Date : Le 23 février 2021	Addenda/Addendum : A-M-01
À/To : Agence spatiale canadienne Centre spatial John H. Chapman 6767, route de l'Aéroport St-Hubert (Québec) J3Y 8Y9	Projet/Project : Agence spatiale canadienne Réaménagement vestiaire des femmes
	N° de projet : 27200022
Att. : Mme Josée Brassard	Propriétaire : Agence spatiale canadienne
Distribution : Par ASC/By CSA

FIN DE L'ADDENDA A-M-01

projet:
PAVILLON 4
RÉFECTION DOUCHES
VESTIAIRES DES FEMMES
 6767 route de l'aéroport, Saint-Hubert, Qc

échéance: INDIQUÉE date: SEPTEMBRE 2020
 dessiné par: YANNICK JOYAL projet: #27200022
 préparé par: ALEXANDRA GIRARD, Ing. feuille: M211

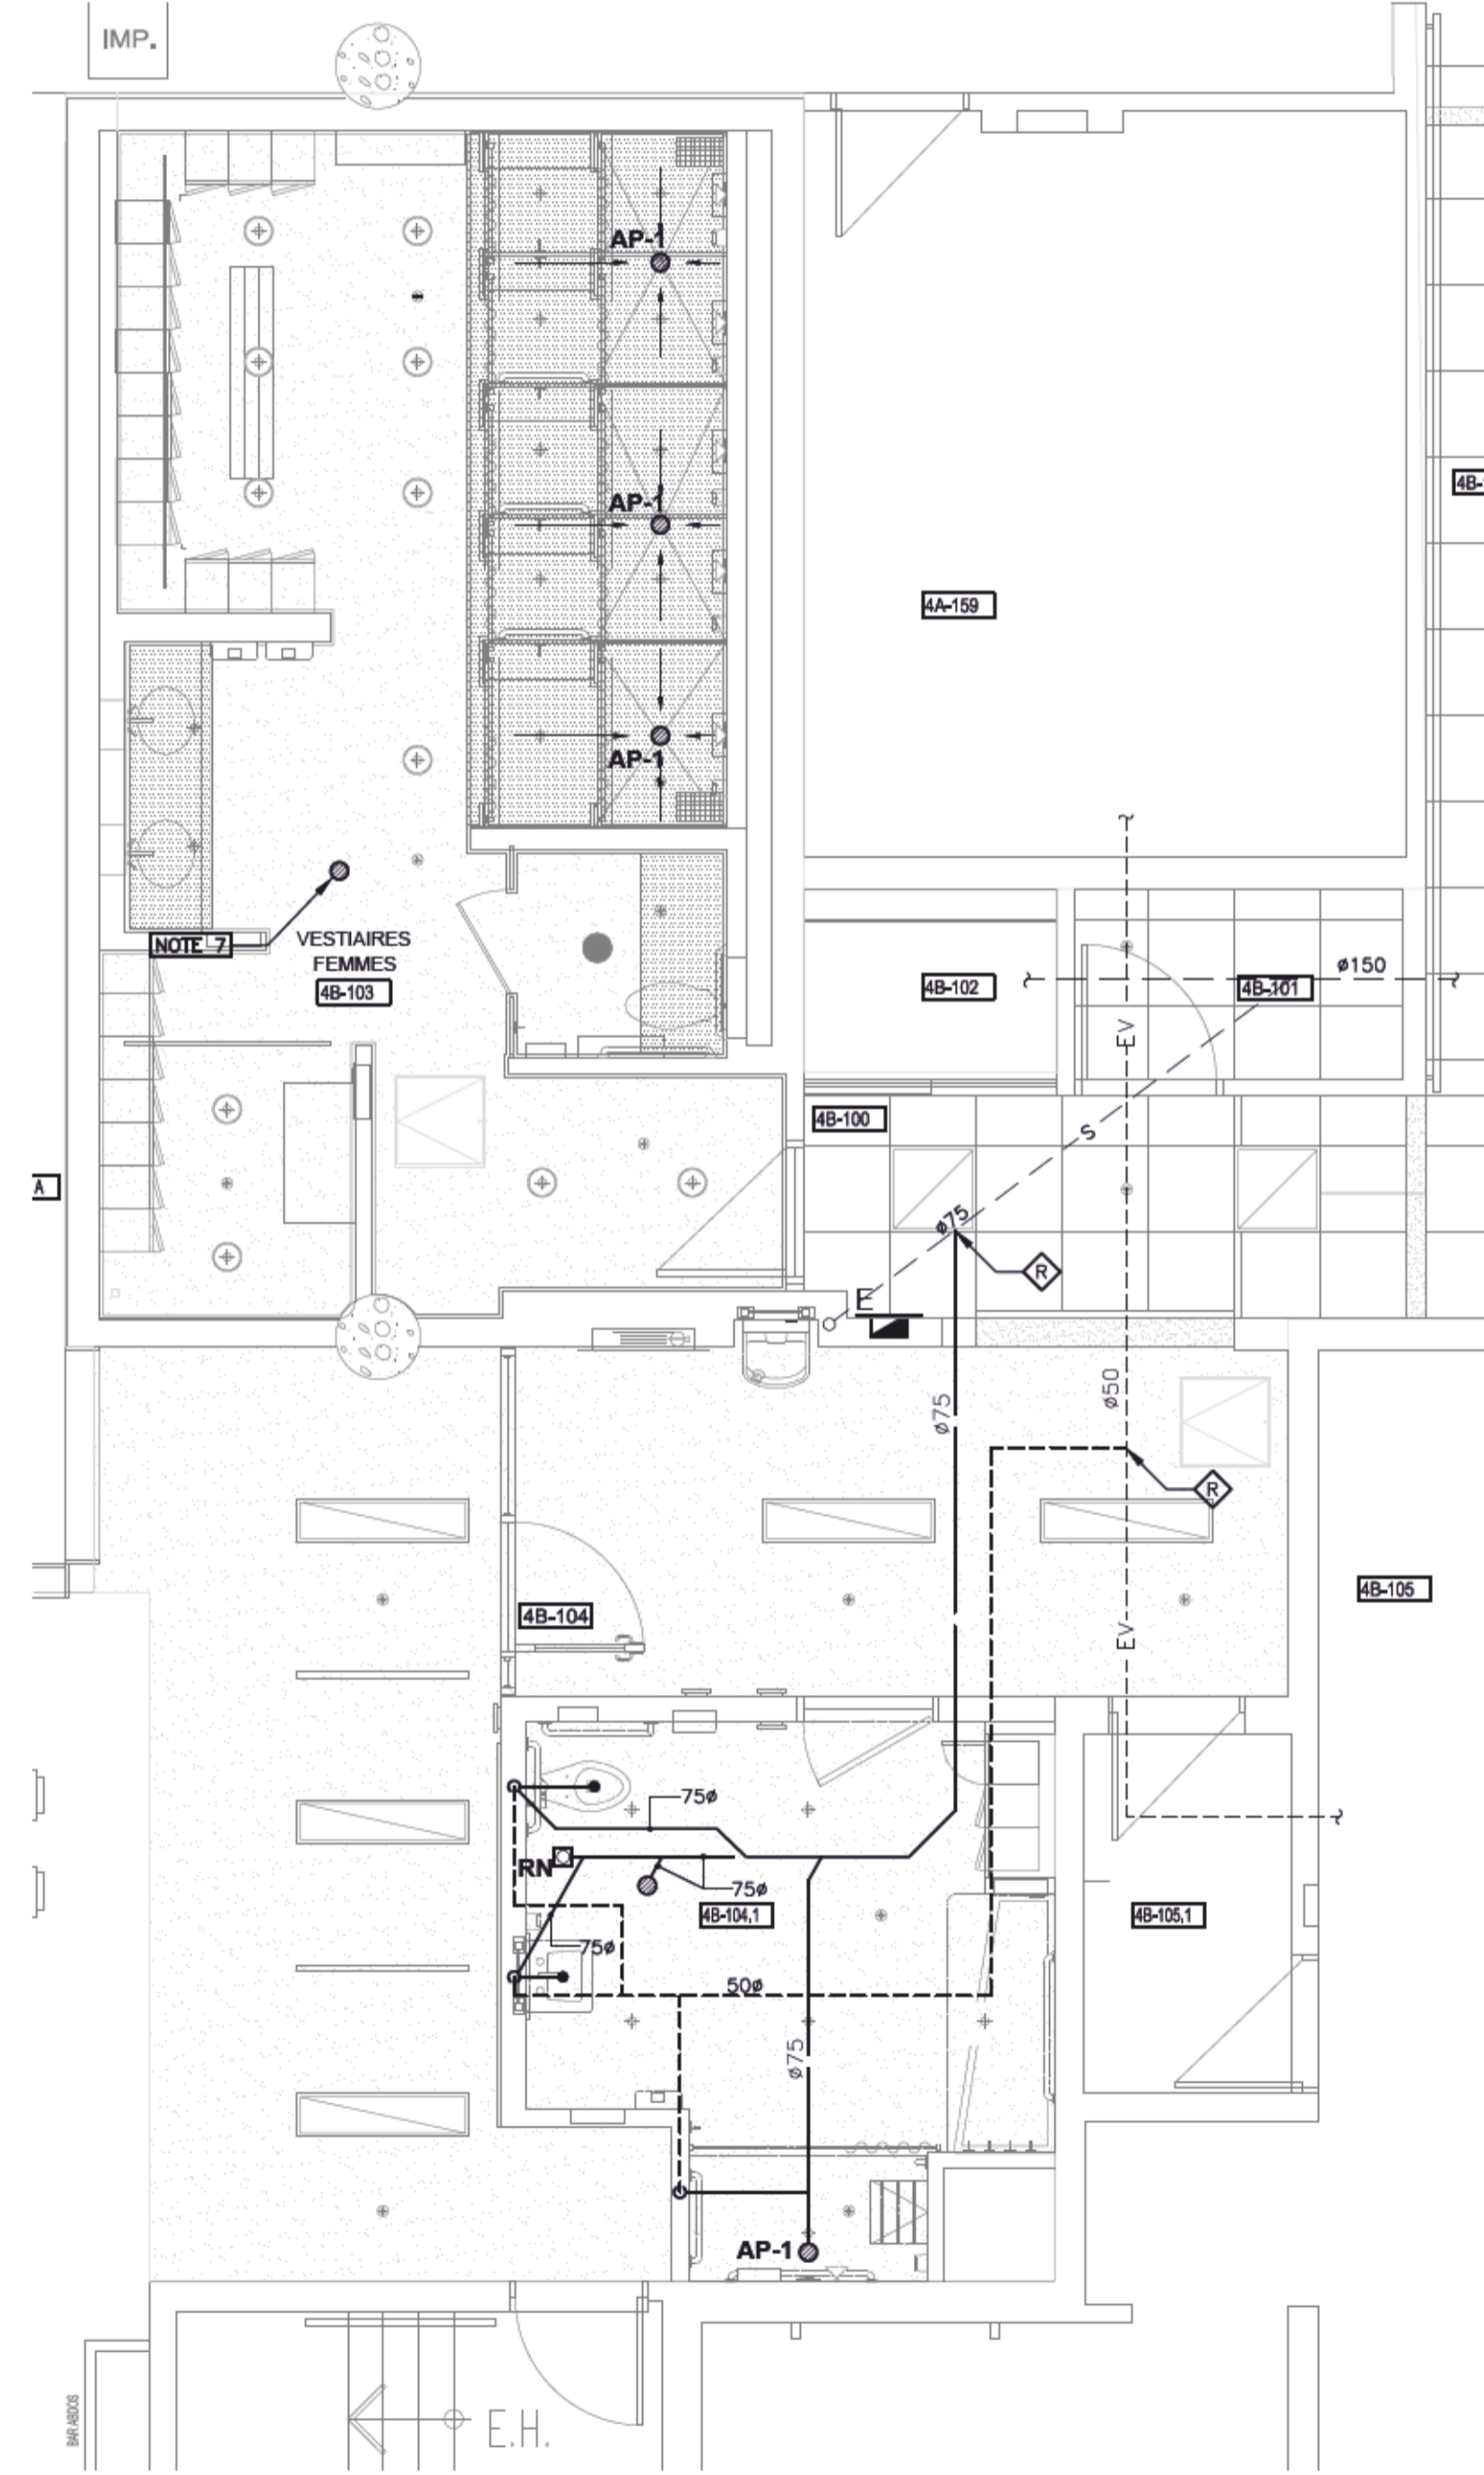
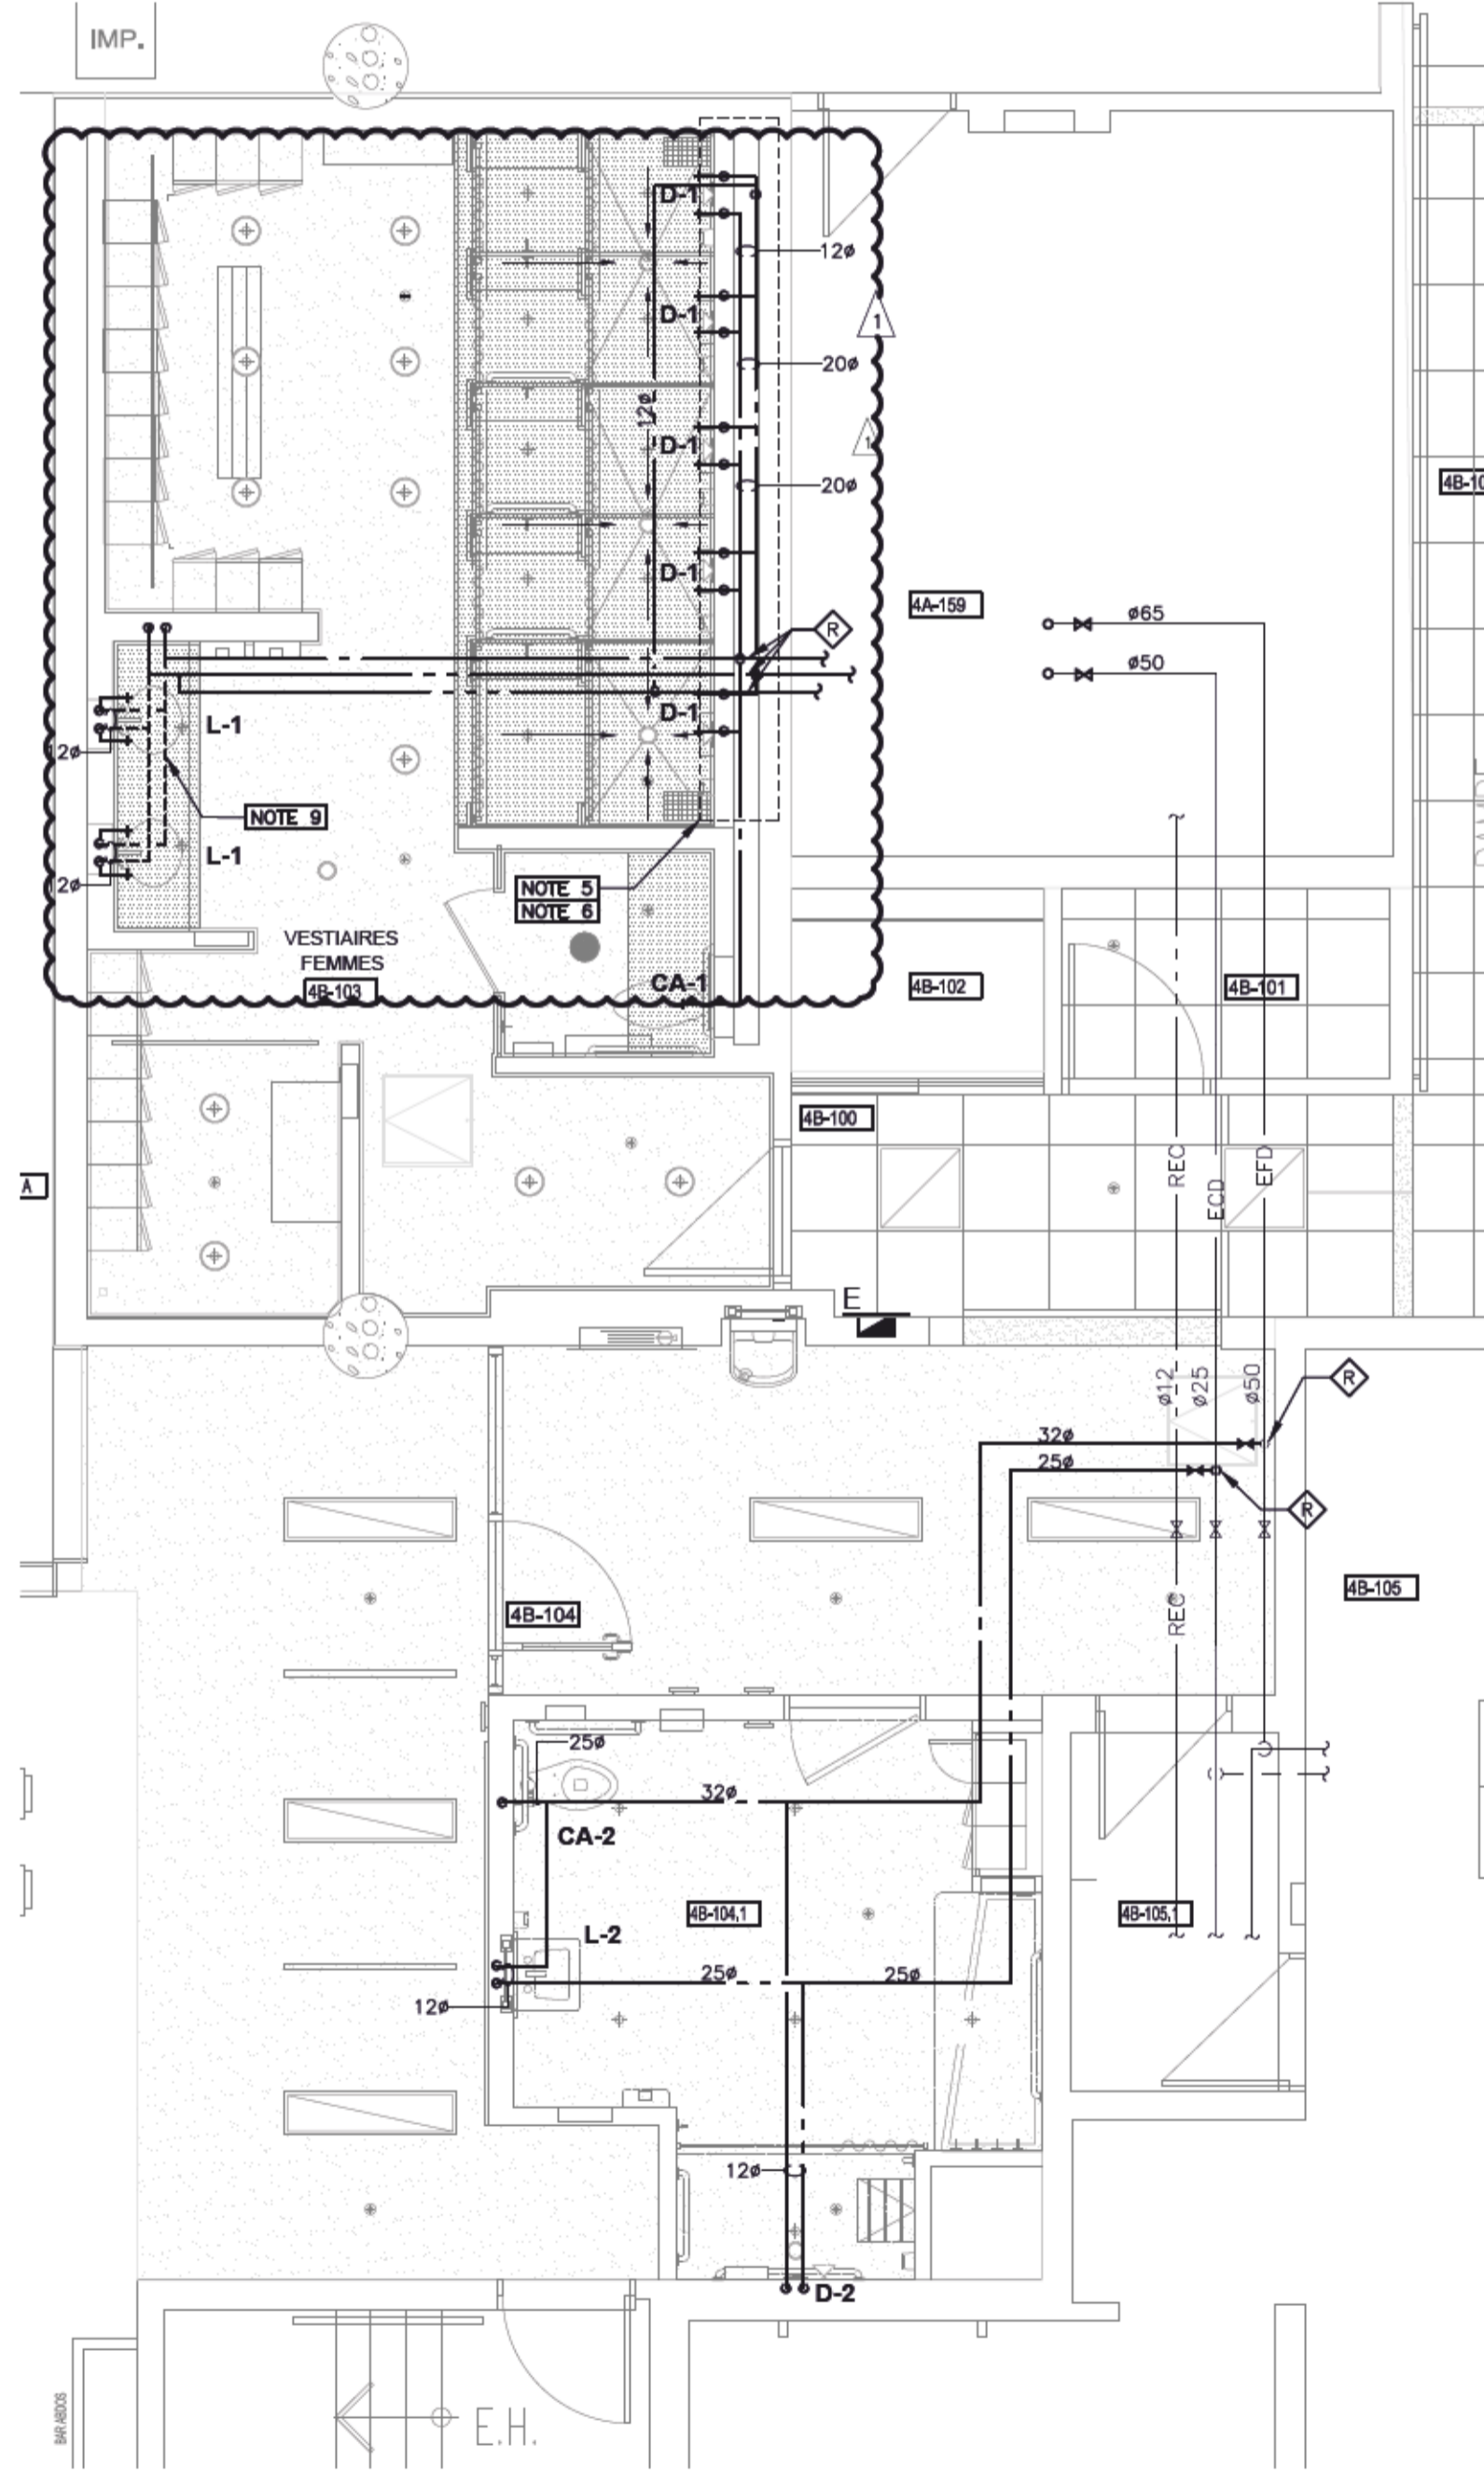
<u>Lexique pour motifs</u>	Motifs
Demande du client : DC Coordination de chantier : CC Coordination des professionnels : CP Conséquence des travaux de base : CB	
<p><i>Le présent addenda fait partie intégrante des plans et devis de mécanique émis pour soumission en date du 19 novembre 2020.</i> <i>This addendum is an integral part of the drawings and specifications issued for tender november 19th, 2020.</i></p> <p>1. <u>MÉCANIQUE/MECHANICAL</u></p> <p>1.1. Plan M211 - Plomberie / Plumbing</p> <p>a) Modification de la portée des travaux de remplacement de la tuyauterie d'alimentation en eau domestique. / Modification of the scope of work for the replacement of domestic water supply piping.</p> <p>1.2. Plan M511 - Ventilation / Ventilation</p> <p>a) Correction du plan concernant le déplacement du conduit de 175mm de diamètre. / Correction of the plan regarding the relocation of the 175mm diameter duct.</p>	<p>DC</p> <p>CP</p>
